Staff Report City of Richmond, Virginia

Commission of Architectural Review

2. COA-109601-2022	Final Review Meeting Date: 4/26/2022	
Applicant/Petitioner	Taylor Bergman	
Project Description	Rebuild a rear deck and fence, and construct a pergola.	
Project Location	3016	
Address: 3108 E. Broad St.	3018 3020	
Historic District : St. John's Church	3102 3104	
High-Level Details:	3102 3104	
The applicant proposes to remove an existing rear deck, shed, and privacy fence.	• St John's Church	
The applicant proposes to construct a new rear deck, privacy fence, pergola, and carport.	3101 · · · · · · · · · · · · · · · · · ·	
The majority of the materials selected for new construction consist of vinyl, PVC, and composite decking.	3103 3105 3107 3109 3111 3113 Chimborazo Park 3200	
Staff Recommendation	Approval, with Conditions	
Staff Contact	Alyson Oliver, alyson.oliver@RVA.gov, 804-646-3709	
Previous Reviews	None	
Conditions for Approval	Staff approval of this request, with the following conditions:

Figure 3. View of existing rear yard privacy fence, looking toward alley.

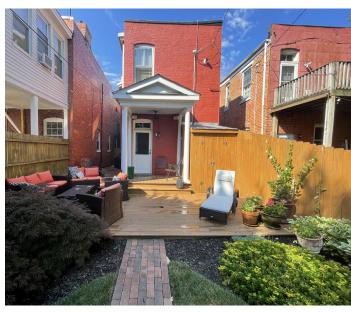
New Construction, Fences & Walls, pg. 51 #3	Privacy fences along the side and rear of a property should be constructed of wood of an appropriate design. Privacy fences are not appropriate in front of a historic building.	The applicant is also proposing to remove the existing wooden rear privacy fence and replace it with a new composite privacy fence. The guidelines specify the rear privacy fences in City Old and Historic Districts should be constructed of wood. Therefore, staff recommends that if the existing rear privacy fence is removed, it be reconstructed of wood and painted or stained a neutral color that complements the main building.
Fences Walls, pg. 78 #9	Rear-yard privacy fences should mimic traditional fence designs.	Specifications on the design of the rear privacy fence have not been provided. Staff recommends that the rear privacy fence incorporate a traditional privacy fence design with vertically-oriented pickets. Final design to be submitted to staff for review and approval.

Fences & Walls, pg. 78 #10	Wooden fences should be repaired and painted as needed. Existing picket designs should be matched when replacement is necessary.	The applicant is proposing to remove and replace the existing rear privacy fence. Staff encourages the applicant to consider repairing the existing fence, rather than complete replacement.

The pergola be constructed of wood and painted or stained a neutral color that complements the main building. Final colors submitted to staff for review and approval.	
	 The carport columns be wrapped in wood and painted or stained a neutral color to complement the main building. 	
	If the existing rear privacy fence is removed, it be reconstructed of wood and painted or stained a neutral color that complements the main building. Any new rear fencing must incorporate a traditional privacy fence design with vertically-oriented pickets. Final design and colors to be submitted to staff for review and approval.
